## **Town of Kittery Maine Planning Board Meeting December 13, 2018**

### **ITEM 3 - 88 Pepperrell Road – The Bistro - Business Use Change Review**

**MEMORANDUM**

**SUBJECT:** 88 – 90 PEPPERELL ROAD – MAP 27 LOT 49

GOOGLE EARTH  
IMAGES  
NOT TO SCALE

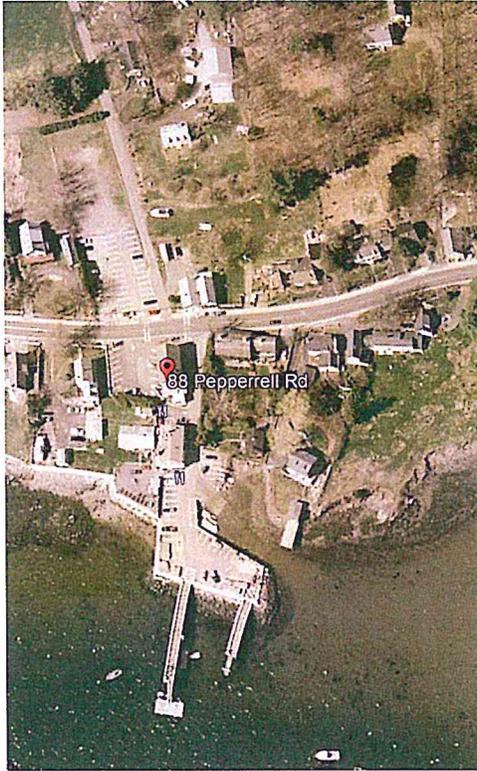
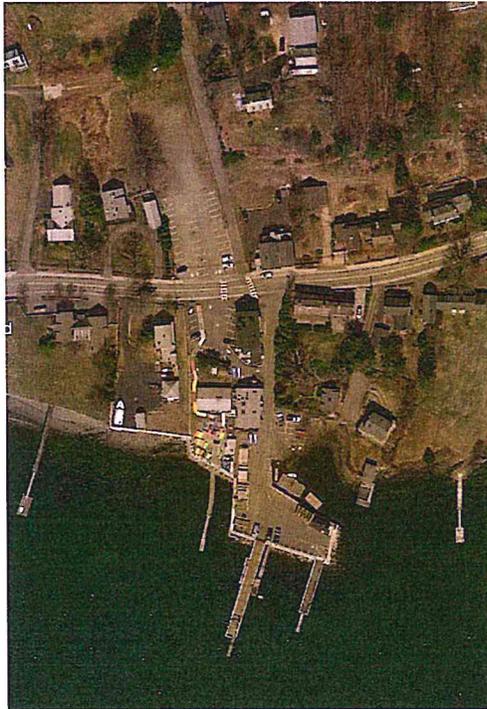
Aerial imagery reflects a walk-way from the south parking lot down to *The Wharf* area, installed in approximately 2012. It is unclear when/if this walk-way was approved. This area may require vegetation.

The exterior seating area previously had partial vegetation and partial crushed stone. The entire exterior seating now has crushed sea shells. The area of vegetation that was removed and replaced with sea shells must be replanted with grass.

PARKING PLAN  
PARKING LAYOUT  
88 PEPPERRELL ROAD (ROUTE 103)  
KITTERY POINT, MAINE

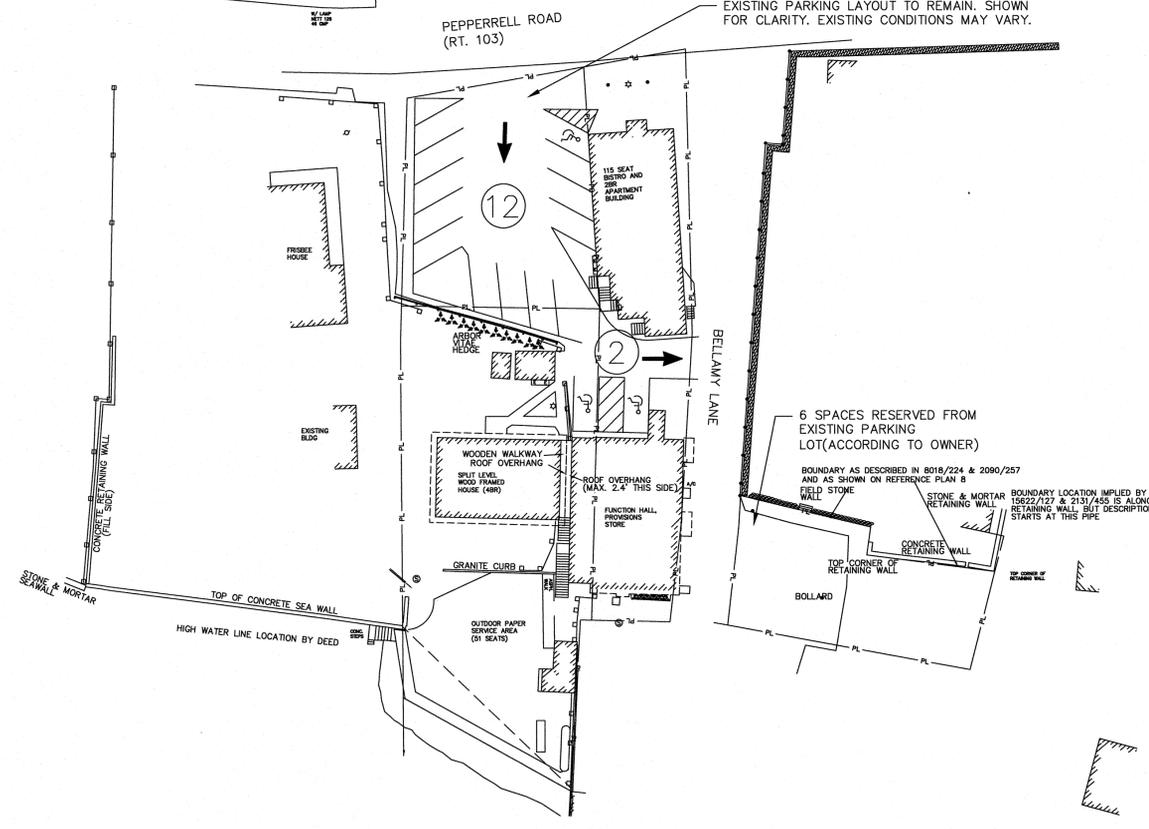
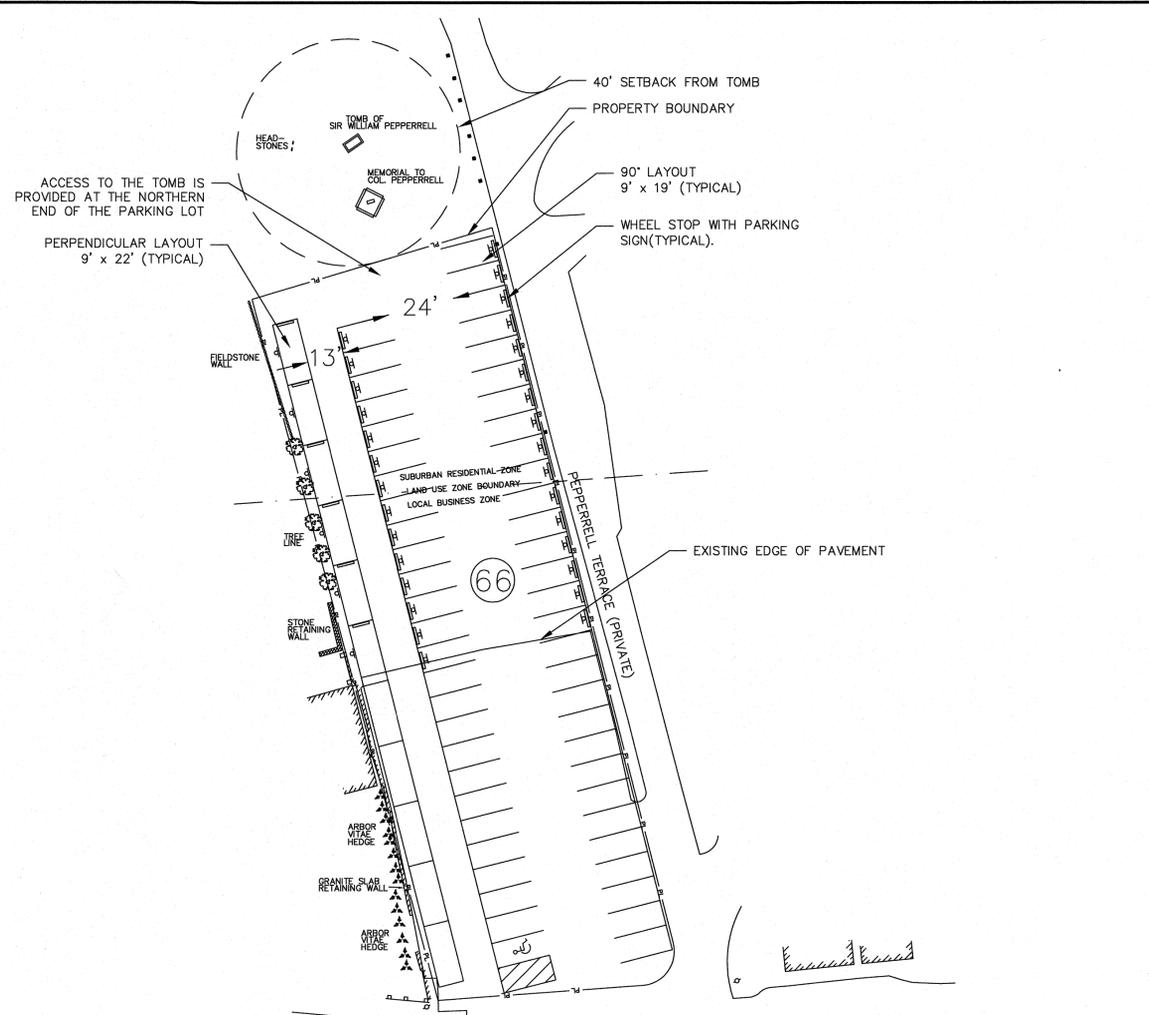
Staff has reviewed the proposal and although we generally concur with the parking calculations, we have concerns with what is presented on the parking plan for numbers, layout and improvements. Specifically:

1. The spaces next to the Bistro and in front of The View will need to be verified. The parking area has recently been repaved and contains no striping. The existing parking layout does not appear to work for flow through travel to Bellamy Lane. The existing deck / stair structure to the rear of the Bistro building further constricts flow through traffic. The plan needs to show more detailed dimensions to ensure proper clearances are met for public safety. There is also a concern for pedestrian safety due to the proposed traffic flow and the constrained spaces of the development area.

3. Dwelling units. There is a separate structure, a 3-bedroom single-family dwelling that requires 2 parking spaces. The parking plan submitted has a note on the single-family dwelling, "split level, wood framed house (4BR)." There doesn't appear to be permits to convert the 3-bedroom dwelling to a 4 bedroom. This needs clarification.  
Per the applicant, the second-floor apartment between the two floors of the Bistro will be converted to storage only. An application for a change of use is required to convert the second floor to storage. Storage would require one (10 parking space per 500 sf of gross floor area. The submitted parking plan identifies this area as a 115 seat Bistro and 2BR apartment. This needs clarification / correction. Code Department is requiring that an "as built" plan for basement, dormers, uses & parking be submitted.

4. The outdoor service area is listed as containing 51 seats yet the plan notes indicate the outdoor seats at 42. Per 16.9.2.2.A in a Shoreland Overlay Zone cutting of vegetation is prohibited within a strip of land extending 100 feet, horizontal distance, inland from the normal high-water line, except to remove safety hazards. Elsewhere in the Shoreland Overlay Zone, the cutting or removal of vegetation is limited to that which is necessary for uses expressly authorized in the zone. The exterior seating area had previous partial vegetation and partial crushed stone. The entire exterior seating area now has crushed sea shells. The area of vegetation that was removed and replaced with sea shells must be replanted with grass. The area that was previously crushed stone that is now sea shells should have been a request to the Planning Board to keep sea shells in the unvegetated area instead of crushed stone. See aerial photos, attached.

5. There is no indication of the traffic flow for the 66-space parking lot to the north nor the location of the proposed on-site parking attendant. Per 16.8.9.1.E, all traffic flow is to be clearly marked with signs and/or surface directions at all times.

6. The parking plans should provide more information relative to off-site impacts, i.e., sight distances along Pepperrell Road, impact upon adjacent access points and intersections like Pepperrell Terrace, turning movements of vehicles entering and existing the site, snow removal and the general condition and capacity of the public streets serving the development.

7. Per 16.8.8.1 Stormwater drainage, previously, there were two (2) storm drains existing in the north parking lot. Both drains have been covered up and don't appear to be functioning and/or existing. The plan should reflect stormwater drainage construction consistent with 16.8.8.1 Stormwater Drainage. Hydrologic analysis may be required. In addition, per 16.8.8.2 Post-construction stormwater management, a post stormwater management plan may be required and engineering review.

8. The submitted parking plan shows an area across Bellamy Lane from The Wharf and View that is designated for six (6) spaces. It is our understanding that these are leased spaces to the owner for kayak parking and cannot be counted towards parking for the uses on this site. The parking calculations in the general notes don't include these spaces but they are shown on the parking plan.

9. Off-site parking for 11 spaces is noted on the plans, however there is no information about their location, any required agreements, or other parking management concerns. Town Code allows off-site parking subject to approval by the Board of Appeals per 16.8.9.4.J.

Applicant see A-F. Need to show traffic flow on plan, and parking areas should be clearly marked with signs and/or surface directions at all times. Off street parking must be constructed in accordance with Table 2 of this chapter.

- Sight distances
- Existence and impact upon adjacent access points and intersections
- Turning movements of vehicles entering and leaving public streets
- Snow removal
- General condition of public street serving the facility

A note on the plan references “access to the tomb is provided at the northern end of the parking lot”. Clarification is needed to show how access to the tomb is achieved by showing traffic flow. The area by the shed & to the rear of *The Bistro* in the south parking lot has been narrowed by stairs for decks.

Plan omits off-street loading bay. Board of Appeals has authority to waive the requirements of this section. A formal request by application must be made to request a waiver on this section.

*The Bistro* is proposed to have 1,634 net sf floor area with customer access which requires 37 parking spaces, per submittal. The Town has not received a detailed floor plan with dimensions and customer access areas for *The Bistro*. This is required to determine gross floor area for parking requirements. This needs to be submitted and determined.

Dwelling units. There is a separate structure, 3-bedroom single family dwelling that requires 2 parking spaces. The parking plan submitted has a note on the single-family dwelling, “split level, wood framed house (4 BR)”. There does not appear to be permits to convert the 3-bedroom dwelling to a 4-bedroom dwelling. This area needs clarification and verification of septic capacity.

The second-floor apartment between the 2 floors of *The Bistro* will be converted to storage only, per applicant. A change of use application is required to convert the second floor to storage. Storage will require 1 parking space per 500sf gross floor area. The parking plan submitted identifies this area as a 115 seat Bistro and 2BR apartment building. This area needs clarification/correction. An “as built” plan for basement, dormers, uses & parking must be submitted.

1. The south side parking area that designates 12 spaces shall be revised to show the existing deck/stair structure and the clearances for the drive thru area to Bellamy Lane. The plan shall show detail and dimensions to ensure proper clearances are met for public safety.
2. The “kayak area” shows 6 parking spaces. The status of these 6 parking spaces are unknown. The Town’s understanding is that these are leased spaces for the kayaks and the leaseholders are Al Damico & R.J. Allister. It appears these parking spaces are already designated and cannot be counted towards parking for other uses on the site, and are only for the kayaks. If there is documentation that states otherwise, please provide it.

There are various discrepancies between the existing approvals, uses on the site, and current parking plan dated 11/27/18 proposed. There should be a clear layout of all the uses, approvals, requests/proposals, and parking requirements in order to review the parking plan proposal.

The parking plan submitted for review states the parking requirement for Provisions store is 2.42 spaces. This area needs clarification.
